# MEMO

**SUBJECT:** BHS Campus Plan – Revised Traffic Assessment and Review

**FIGURE 2: PROPOSED BHS CAMPUS (REVISION DATE 6/8/20)**

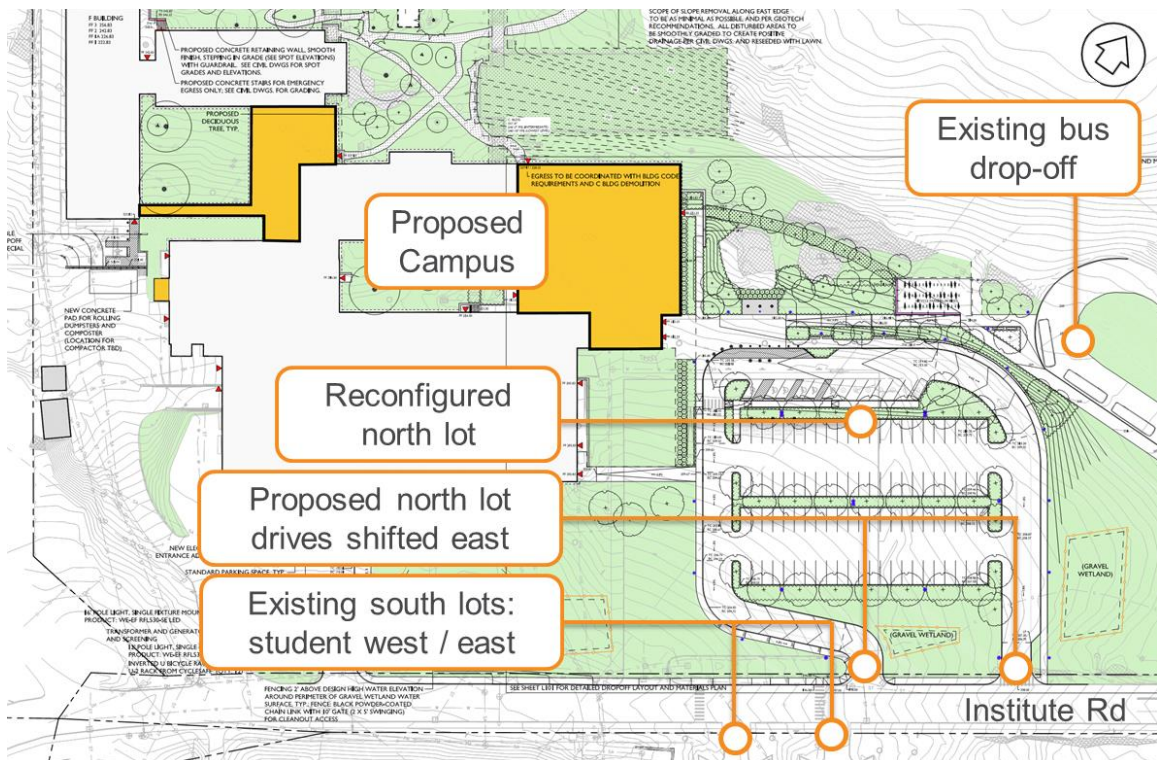
Compared to the previous campus design presented in earlier traffic assessment, the layout of the revised PNL will operate much more similarly to the existing conditions. Buses will remain on a separate loop directly off North Avenue. Personal vehicles will access the campus from Institute Road. The existing one-way circulation pattern is recommended to remain.

Both the entrance and exit drives to the north lot will shift east along Institute Road. The proposed eastern entrance drive is approximately 240-feet west of North Avenue (the existing drive is approximately 370-feet west of North Avenue, and the previous design drive was approximately 260-feet west of North Avenue), and the proposed western exit drive is approximately across from the south lot east drive.

**FIGURE 5: MAXIMUM QUEUES FROM SIMTRAFFIC MODEL ALONG EB INSTITUTE ROAD AND SB PROPOSED NORTH LOT EXIT**

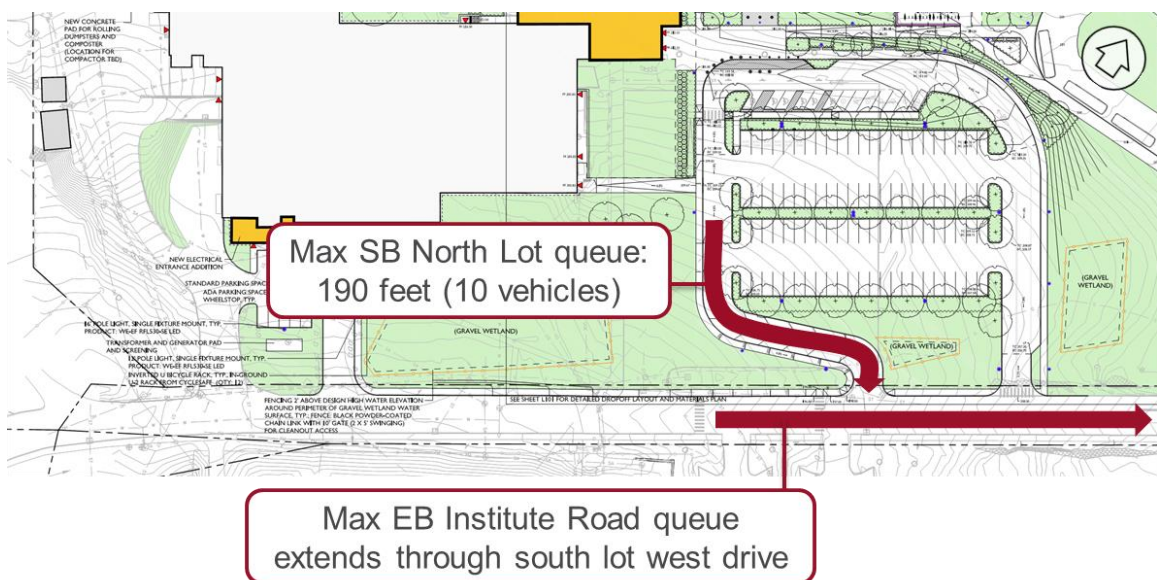
As discussed in the previous analysis, the queues modeled are unlikely, and would only approach that length for one or two cycles during the peak 10-minute dismissal period from 3:05 to 3:15. Outside of this period, traffic volumes are lower and congestion is not an issue.
